TOWN OF BAY HARBOR ISLANDS
DEVELOPMENT & REVIEW COMMITTEE MEETING
RESCHEDULED, TUESDAY, NOVEMBER 15, 2022

1. Review and discussion of Site Plan Application by PPG BHT Owner, LLC to construct a 44-unit Multi-Family Development to be located at 10143 East Bay Harbor Drive. Enclosed are the Site Plans and the Staff Report prepared by Town Planner Michael Miller.
2. Review and discussion of Site Plan Application by CHBH 103rd Street, LLC, to construct a 77-unit Multi-Family Development to be located at 10200-10290 East Bay Harbor Drive. Enclosed are the Site Plans and the Staff Report prepared by Town Planner Michael Miller.
3. Review and discussion of Site Plan Application by DDG 1055 BHI, LLC, to construct a 9-unit Multi-Family Development to be located at 1055 93 Street. Enclosed are the Site Plans and the Staff Report prepared by Town Planner Michael Miller.

**TOWN OF BAY HARBOR ISLANDS
COMMUNITY DEVELOPMENT
MEMORANDUM**

Subject: Site Development Plan Application – DRC Review #3
Proposed New Multiple-Family Development (44 DU)
Existing Bay Harbor Tower Site (30 DU)
10141-10143 East Bay Harbor Drive
Bay Harbor Islands Acct. No. SPR22-000024
MMPA Acct. No. 01-0702-1142

Date	10-27-2022	Sheet No.
Scale		A5.00
Project	0000

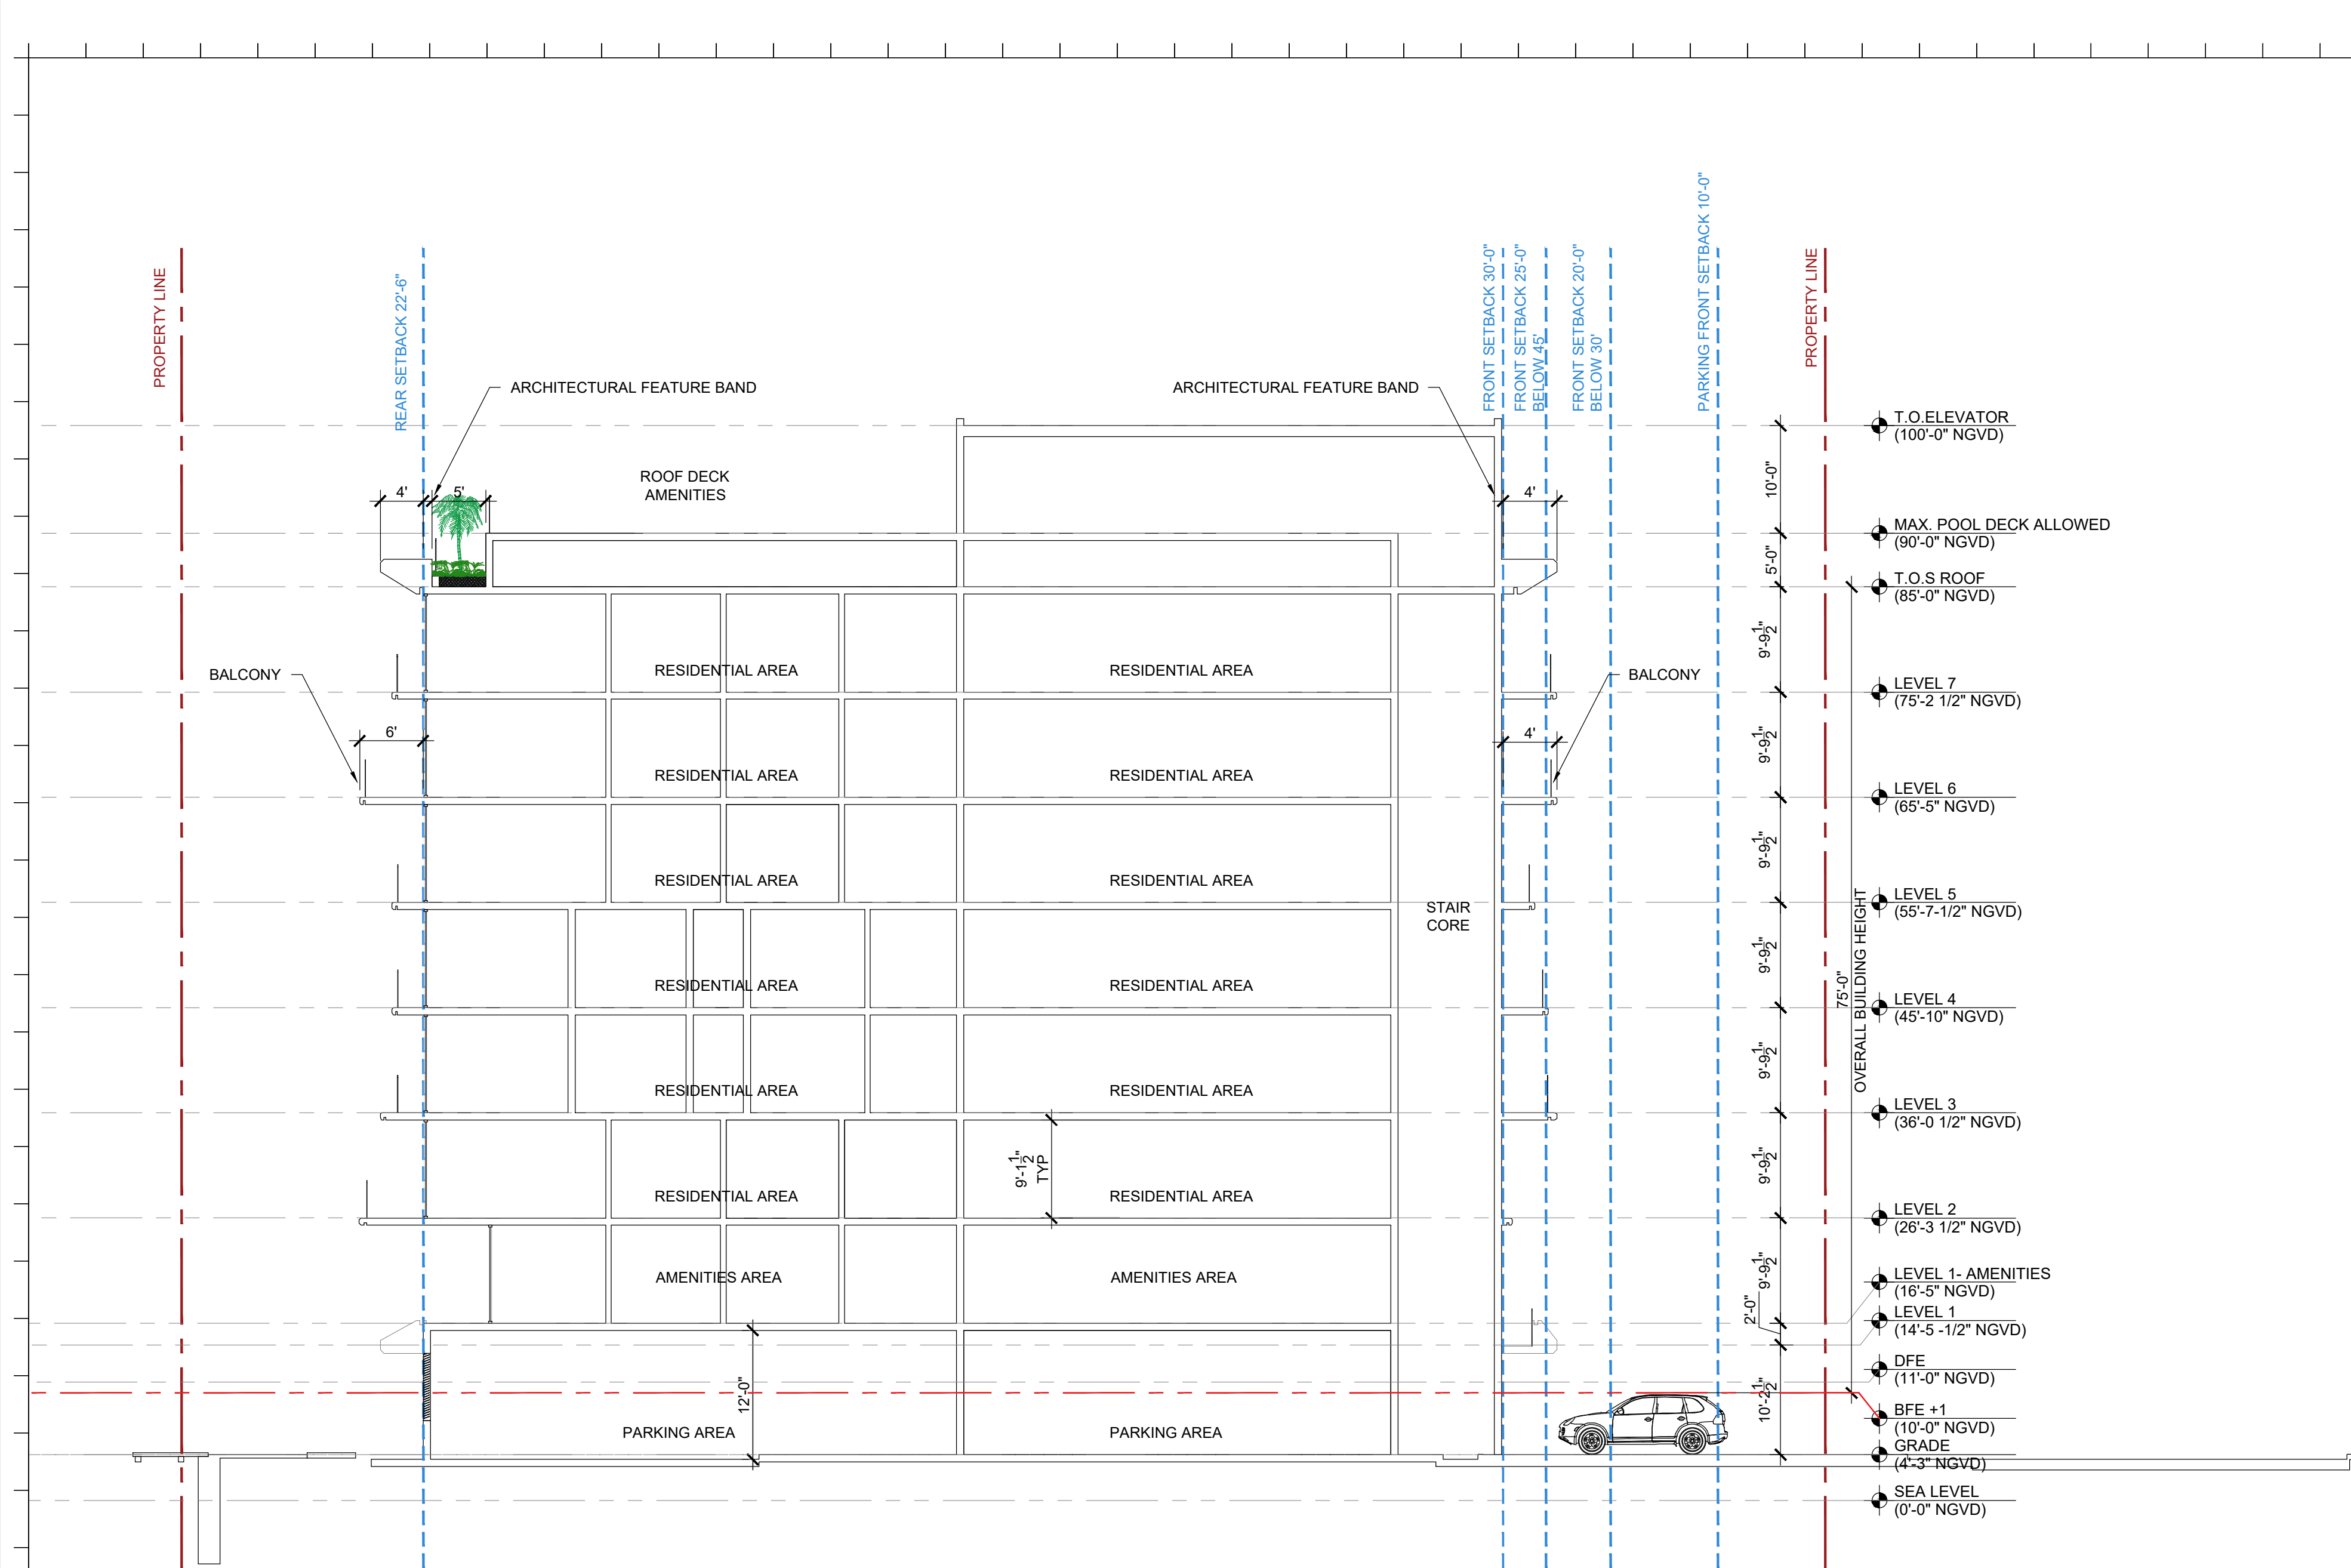
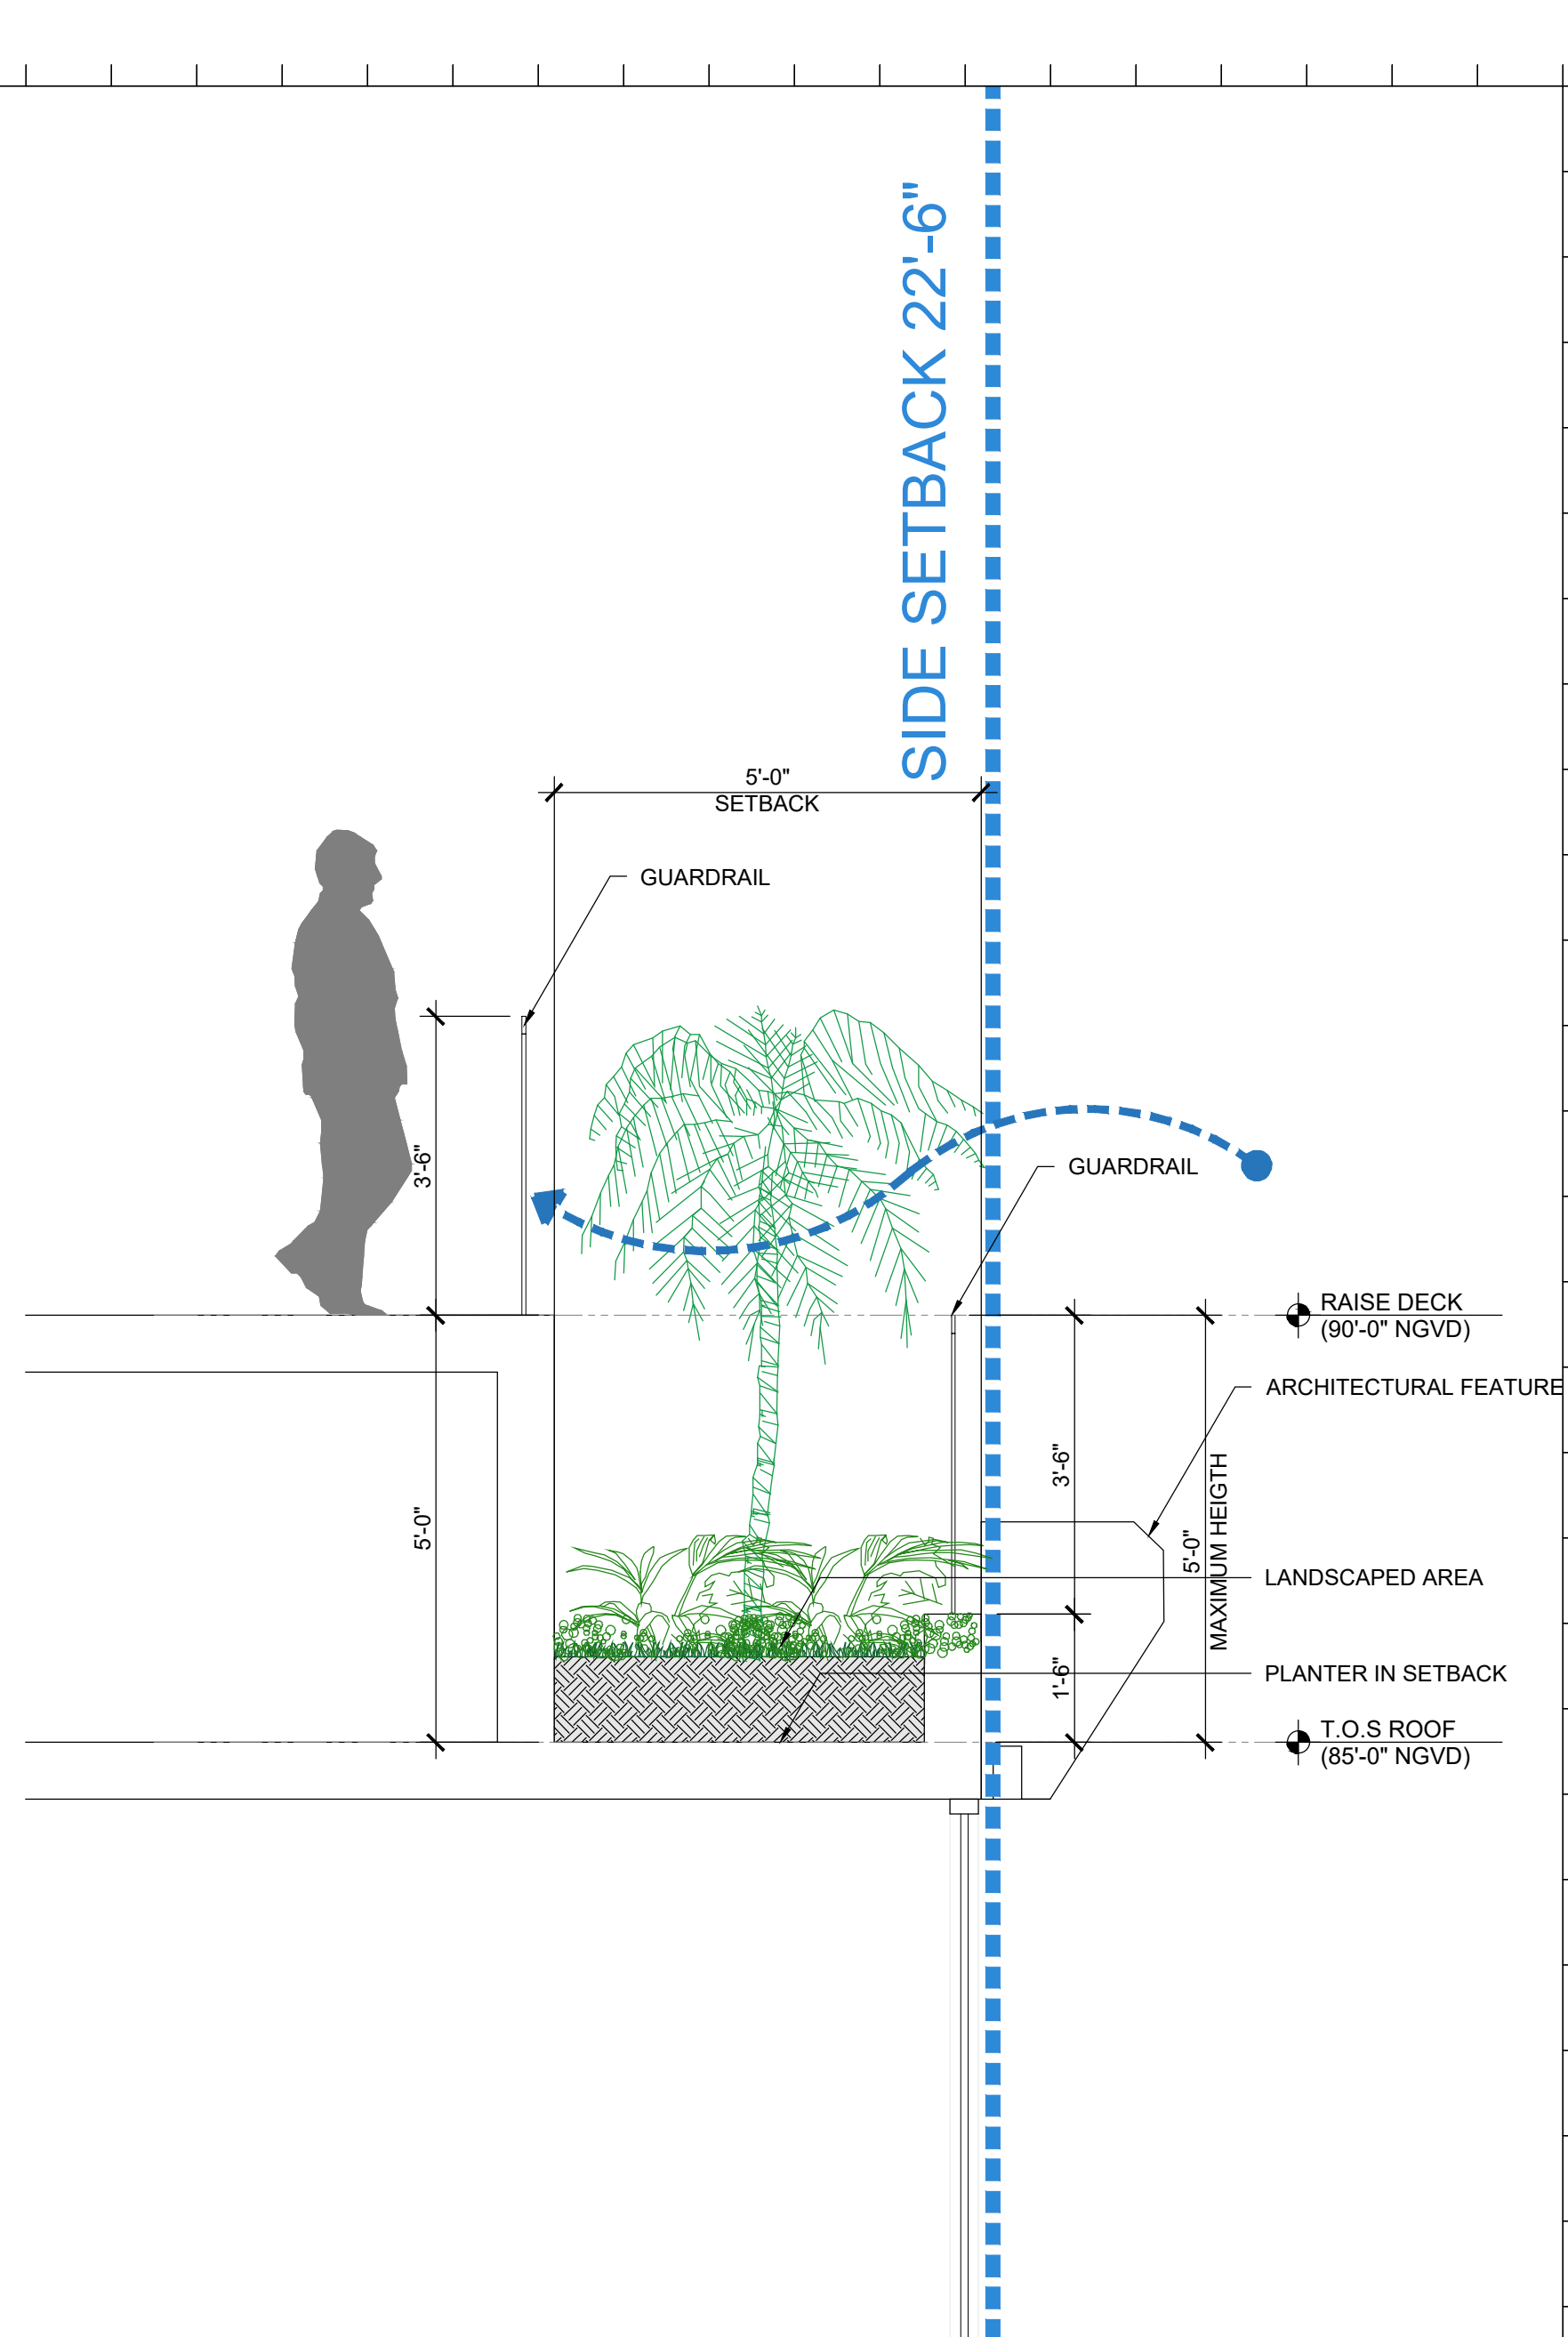
5	On Sheet A2.00 I Sheet A3.00 I others there appears to be some type of private terraces near the semi-private swimming pools at grade level. Not enough detail is provided to determine Code compliance as to setbacks / materials/ roof coverings I height/ etc. The elevations seem to show a roofed structure - so setbacks are required. Please revise the plans accordingly. See Sec. 23-12(15)(e)(iii) for Code allowances.	Roofed Structure has been removed. Plans have been revised accordingly. A2.00 & A3.00.A5.01-B
	6	It appears that portions of the 5' raised rooftop pool deck do not meet the minimum 5' setback requirement from the edge of the main roof as required by Sec. 23-25(e). A parapet wall / railing not exceeding 5' above the roof deck is allowed at the edge of the main roof; however, if there is a raised pool deck, a similar safety railing / wall is allowed at the edge of the raised deck - but no closer than 5' to the edge of the main roof.	Please see sheet A5.00-B to find a detailed section of the area in compliance with this requirement.
